Access Compliance Report

Public Rights-of-Way

(Curb Ramps)

Intersection ID: 32204	Main Street: LANCKEN_DR	Cross Street: PROVINCETOWNE_DR	Location: SW
ADA ID: 02DBB0977D8D	Ramp Type: BlendTrans1	Initial Pass/Fail: Fail	Overall Compliance: No
Severity Score: 12.5			
Codes/Mitigation Info/Possible Solution		Field Measurements/Component Compliance

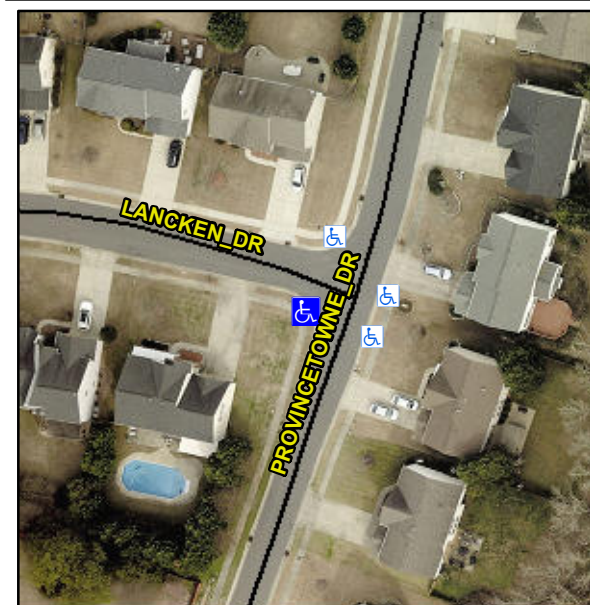
Not Found, R304.5.3

Compliance	Description	Data	Compliance	Description	Data
N/A	Ramp Length (in)	47.0	Yes	BlendTrans Slope (%)	4.5
Yes	Ramp Width (in)	62.0	No	BlendTrans XSlope (%)	5.3
N/A	Flare Type LT	N/A	N/A	Flare Type RT	N/A
N/A	Flare Slope LT (%)	N/A	N/A	Flare Slope RT (%)	N/A
N/A	Flare Traversable LT?	N/A	N/A	Flare Traversable RT?	N/A
N/A	Landing Length (in)	N/A	N/A	DWS Provided?	N/A
N/A	Landing Width (in)	N/A	N/A	DWS Contrast?	N/A
N/A	Landing Slope (%)	N/A	N/A	DWS Length (in)	N/A
N/A	Landing X Slope (%)	N/A	N/A	DWS Full Width?	N/A
N/A	Landing Curb? (Y/N)	N/A	N/A	DWS Offset (in)	N/A
N/A	Shared Landing?	N/A			
N/A	Gutter Ponding?	N/A	N/A	Gutter Slope (%)	N/A
N/A	Gutter Lip Ht (in)	N/A	N/A	Gutter X Slope (%)	N/A
N/A	Painted X Walk1?	No	N/A	Painted X Walk2?	No
	X Walk 1 Direction	To SE		X Walk 2 Direction	To NE
	X Walk 1 Width (in)	N/A		X Walk 2 Width (in)	N/A
	X Walk 1 Slope (%)	1.0		X Walk 2 Slope (%)	0.6
	X Walk 1 X Slope (%)	2.0		X Walk 2 X Slope (%)	0.5

N/A	Ramp inside XWalk1?	N/A	N/A	Ramp inside XWalk2?	N/A
	Road Slope (%)	2.9		Clear Space?	N/A
	Road X Slope (%)	1.2	N/A	Clear Space to XWalk (in)	N/A
N/A	Any Obstructions?	N/A	N/A	Storm Grate/Utility Hazard?	N/A
	Obstruction Type			Storm Grate/Utility Type	
		N/A			N/A
			Yes	Surface Condition? (G/P)	Good
			No	Curb Slope (%)	5.6

Remove & Replace Curb Ramp With Two New Directional Ramps or Equivalent.
